## **Mazda 2 (B2W)**

### **Changed refrigerant filling quantity**

Bulletin

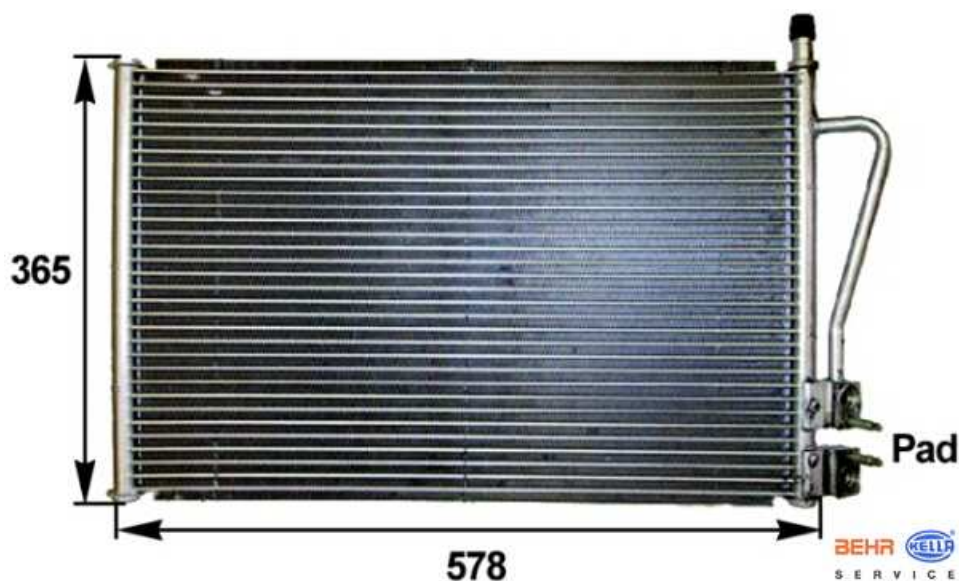
In the case of the above-mentioned vehicles, the refrigerant filling quantity has changed from model year January 2007 due to a modified condenser. The new refrigerant filling quantity is 470 g. The modified OE condensers of the manufacturer Visteon now have a lower flat-tube cross-section. So that performance is retained with the same matrix dimensions, the number of flat tubes was increased from 32 to 38. As the modified OE or Visteon condensers are now also offered as replacement condensers for vehicles prior to model year 2007, the filling quantity must be adapted accordingly during installation. If *Behr Hella Service* condensers are used (see picture, part no. 8FC 351 300-351), the air-conditioning system should still be filled with the old refrigerant filling quantity of 650 g.
